ALERT SERVICE BULLETIN

NO. 205B-01-36

MODEL AFFECTED: 205B

SUBJECT: CHIP DETECTOR ASSEMBLY, TEDECO B3703

FIGURE 1

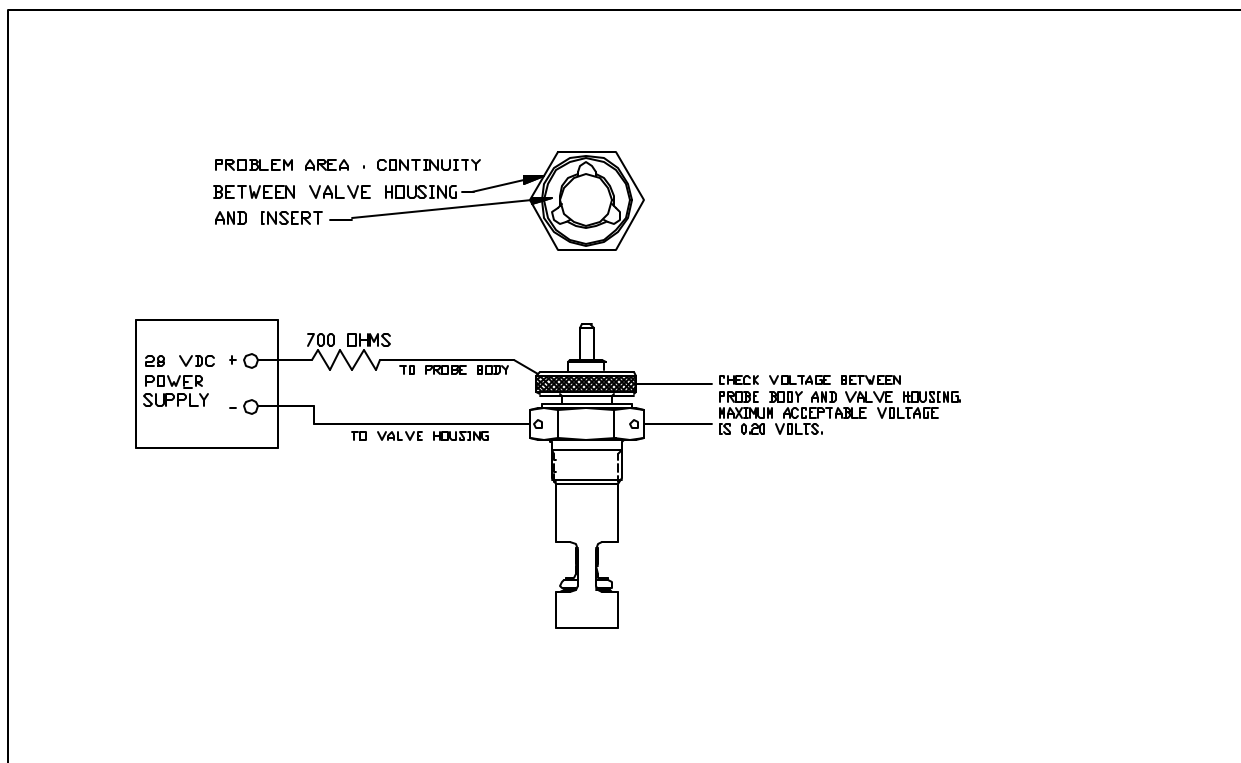
1. Connect the chip detector to a 28 Volt DC power supply using a 700 ohm, 2 watt resistor as shown in Figure 1.
2. Measure the voltage between the probe body and the valve body. The voltage drop must be 0.20 volts or less across the unit. If the voltage drop is larger than 0.20 volts, then return the unit to Tedeco (See 3. Part Replacement.)

FIGURE 2

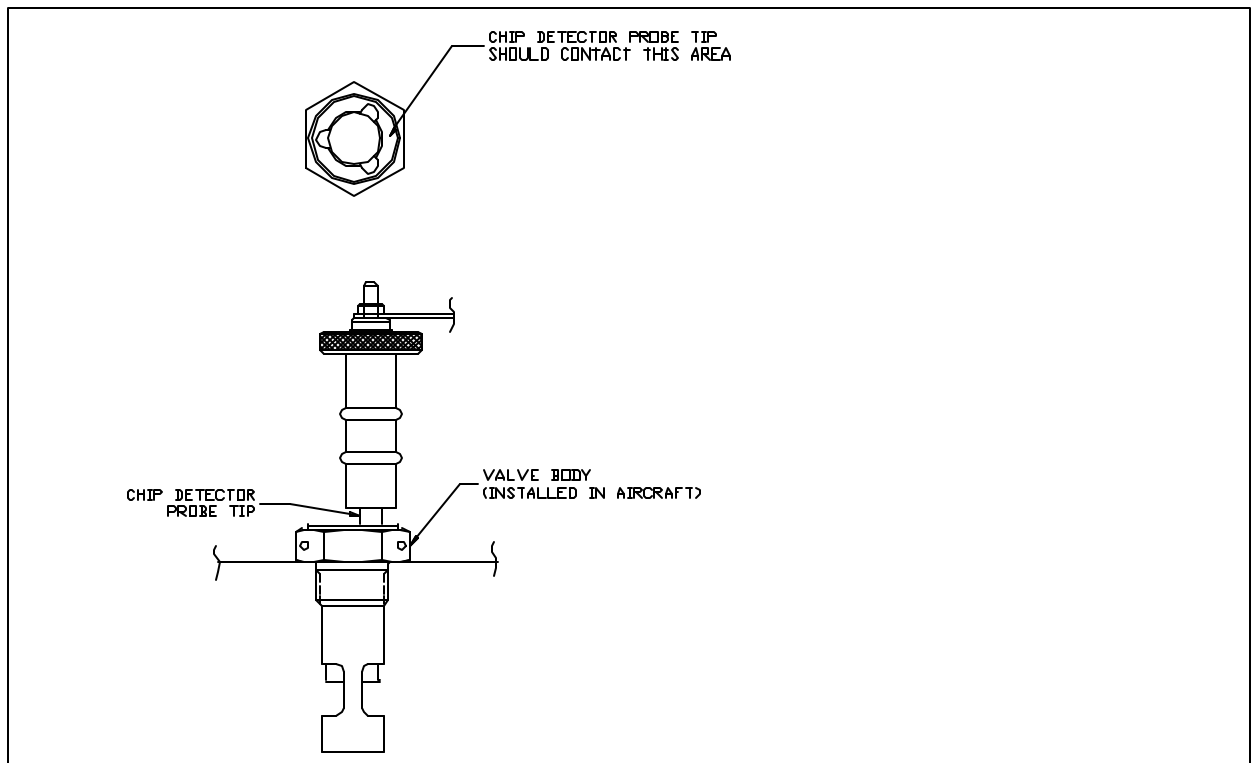
1. Ensure that electrical power is supplied to the chip detector.
2. Remove the chip detector probe from the self-closing valve.
3. Hold the tip of the center stud of the chip detector probe firmly against the steel insert as shown in Figure 2 while checking chip indicator light in cockpit. If the cockpit light illuminates, the unit is acceptable. If the light does not illuminate, then proceed to the next step.

FIGURE 3

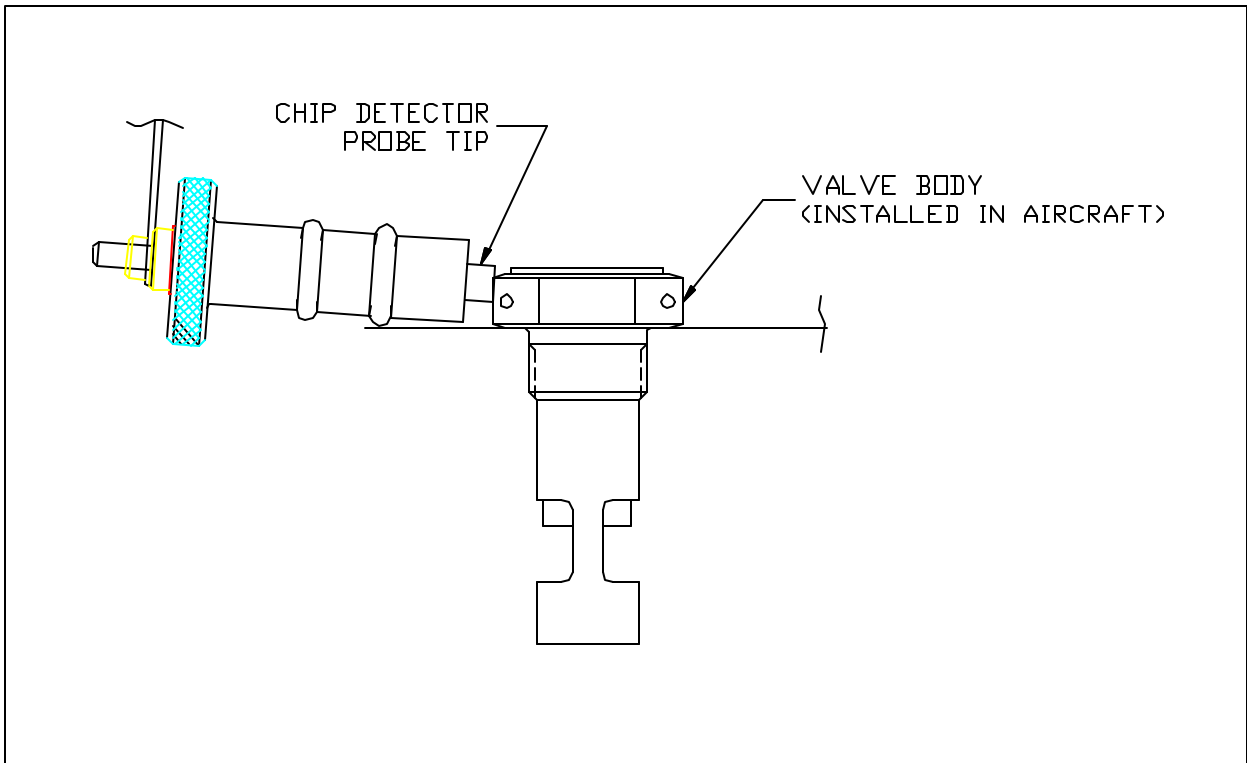
4. Hold the tip of the center stud of the chip detector probe firmly against the valve housing as shown in Figure 3 while checking chip indicator light in cockpit. The cockpit light should illuminate. Illumination of the light in this step isolates the electrical discontinuity to the valve insert. Repair the unit per the repair instructions in section 2 of this document.

FIGURE 4A

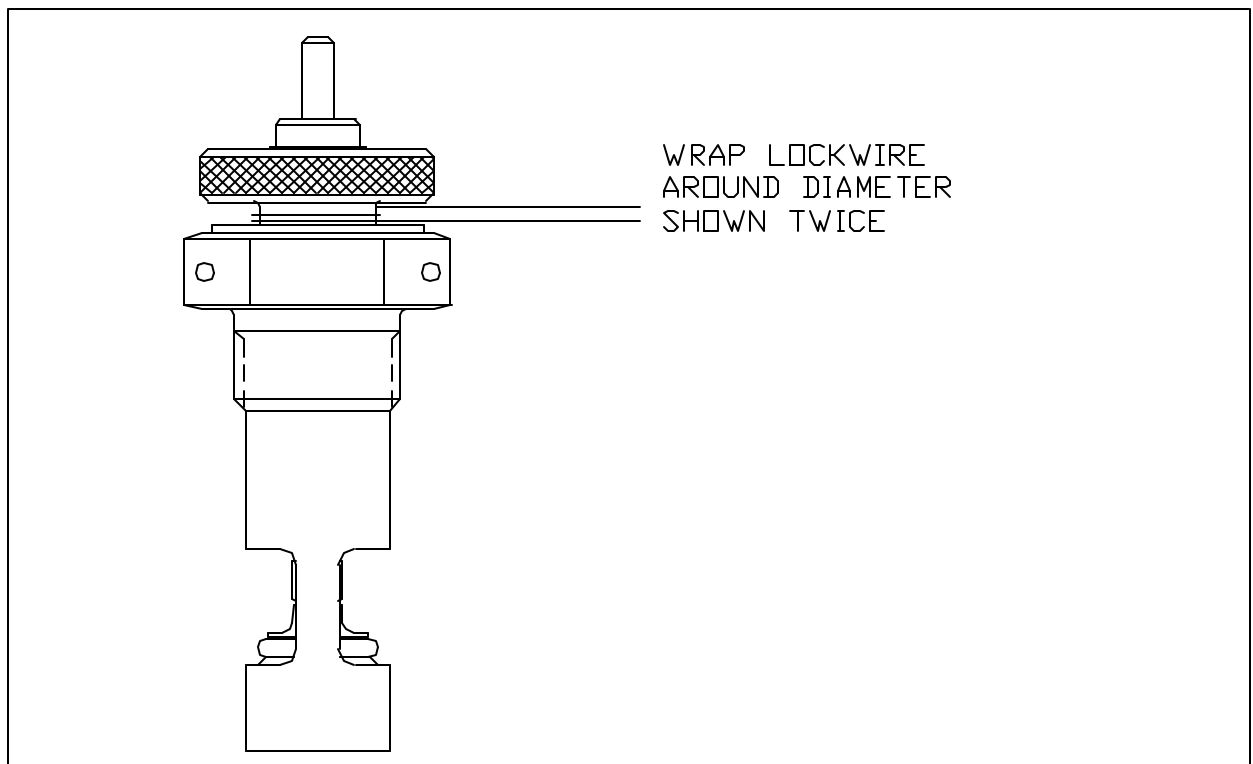
- 2.1. Install Chip Detector Probe into Valve assembly.
- 2.2. Tightly wrap a piece of lockwire (approx 6 inch length) around the chip detector probe diameter shown two full times. (See Figure 4A.)

FIGURE 4B

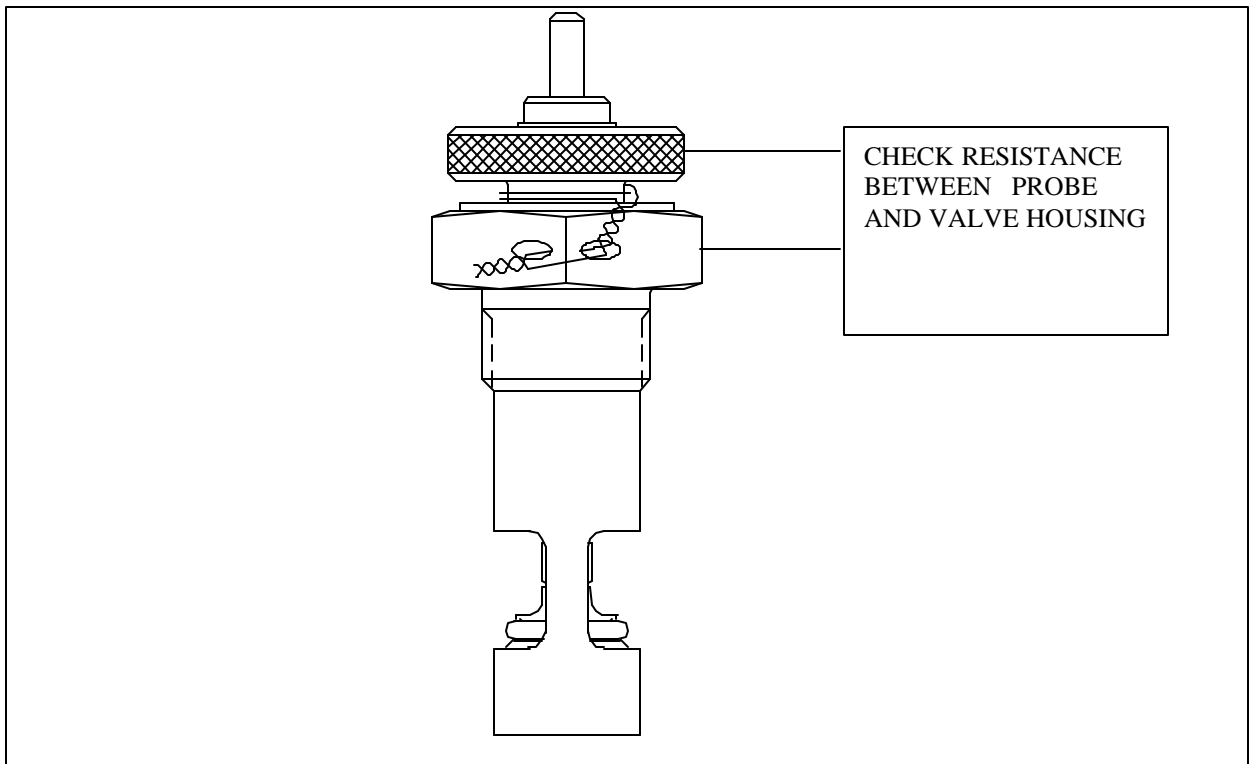
- 2.3. Twist two ends together approximately five times until twisted section reaches nearest free lockwire hole. Ensure that lockwire is tightly wrapped.
- 2.4. Slide one end of lockwire through the lockwire hole. Continue twisting two ends together to complete the lockwiring. (See Figure 4B.)
- 2.5. Check repair by using an ohmmeter to check resistance between the chip detector probe and the valve housing. Resistance should be 1 ohm maximum. (See Figure 4B.)
